SERVICE DIRECTIVE BULLETIN

Number 0055

Subject: Clutch Control System Rigging and Heat Protection

Models: F-28A, 280, F-28C, F-28C-2, 280C, F-28F and 280F

Figure 1

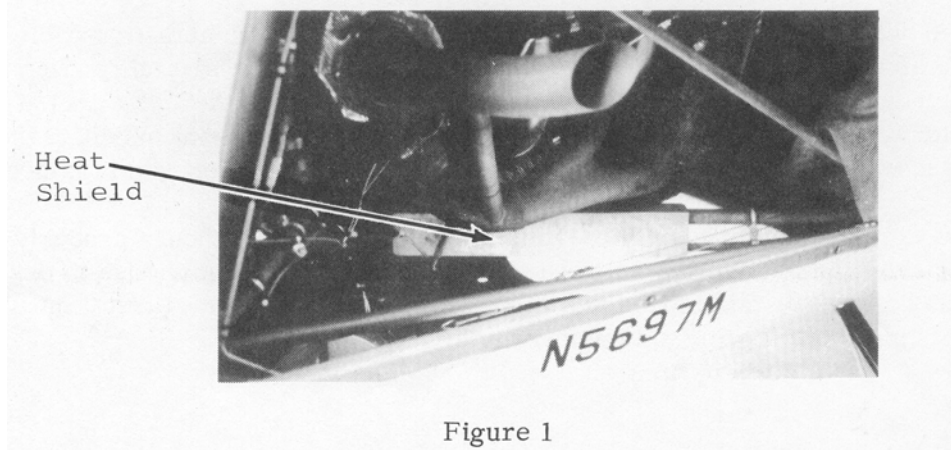
It is required that a clutch control heat shield, P/N 2 8-16542, be installed within the next 25 hours of operation to protect the clutch actuator cable from the radiant heat emission from the exhaust system (ref. Fig. 1). The heat shield and installation drawing 28-16500 can be acquired from Enstrom Customer Service.
